FUNG GEN

85-01-0042

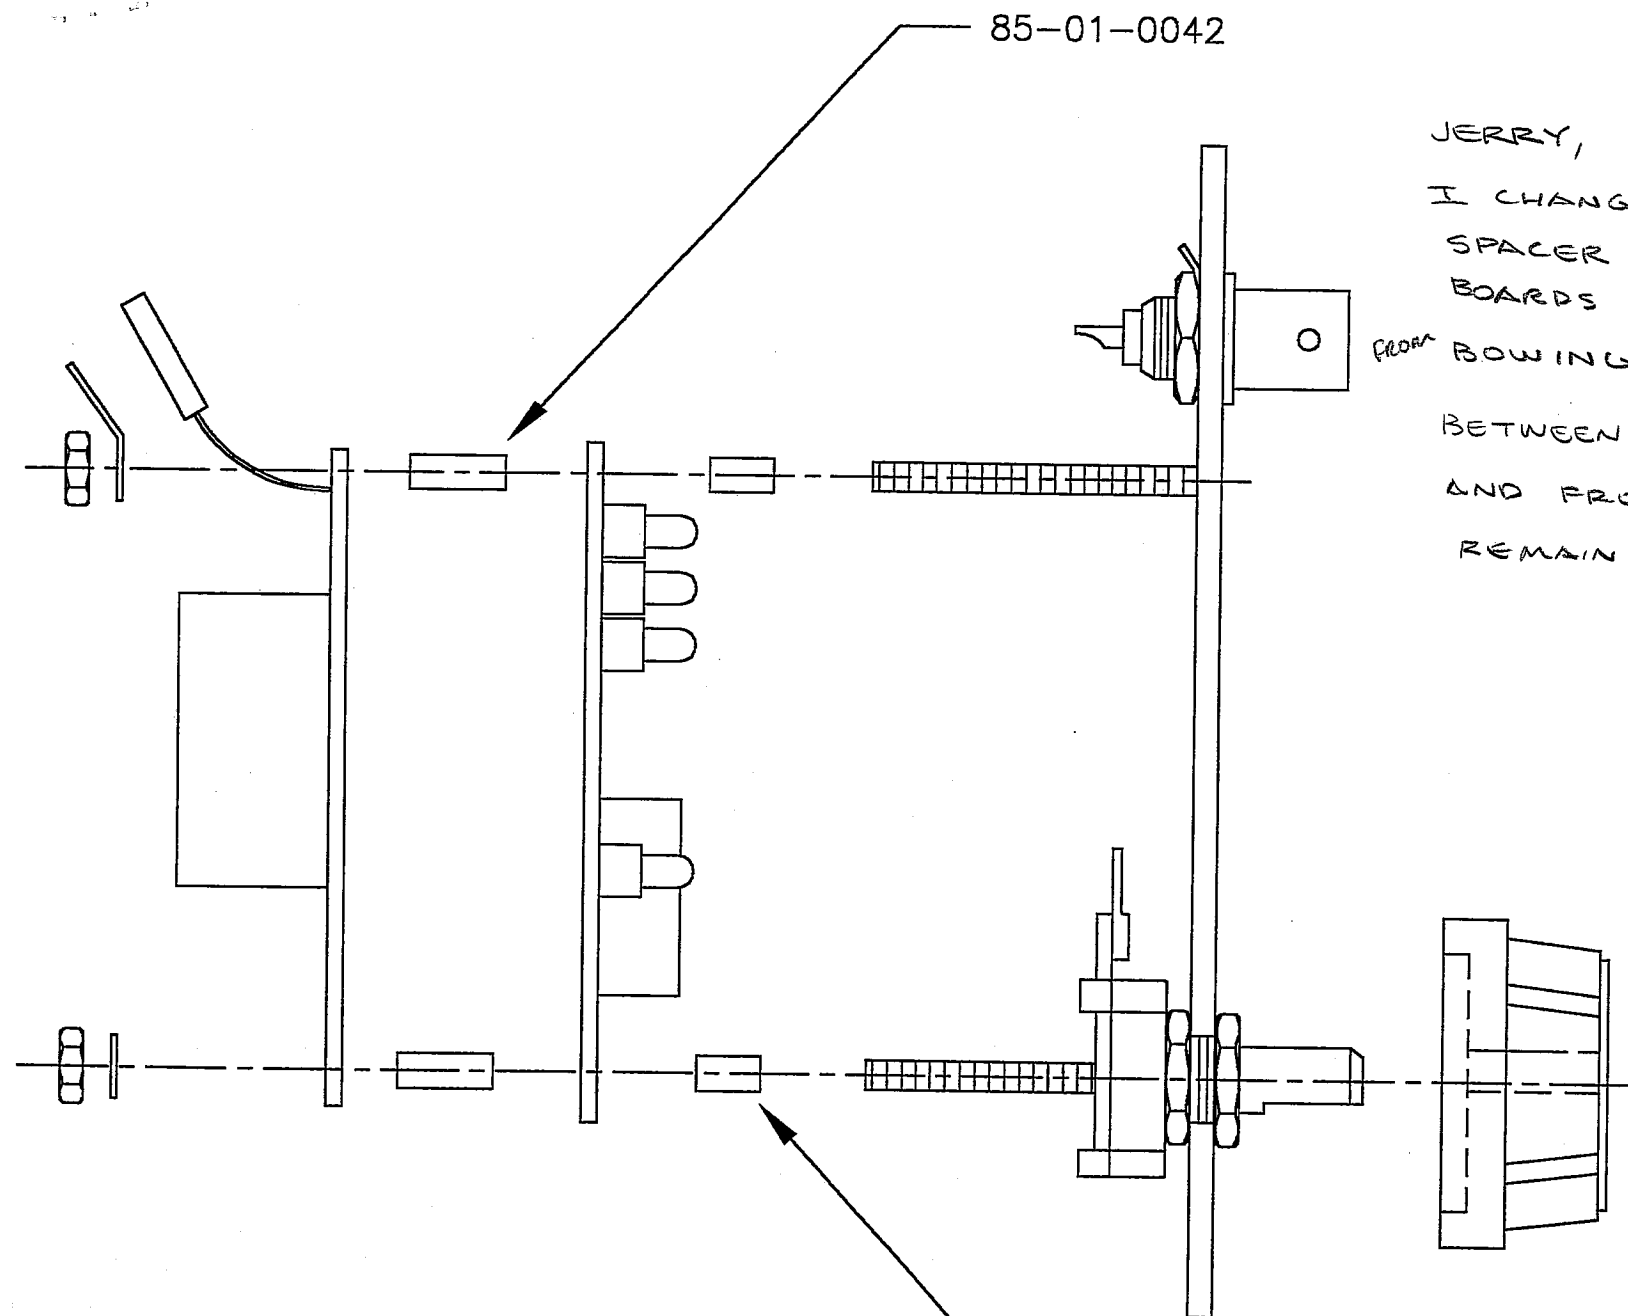
JERRY,
I CHANGED THE
SPACER BETWEEN
BOARDS TO PREVENT THEM
FROM BOWING. THE SPACER
BETWEEN THE BOARD
AND FRONT PANEL
REMAINS THE SAME.

~~85-01-0004~~

85-01-0042

1.375
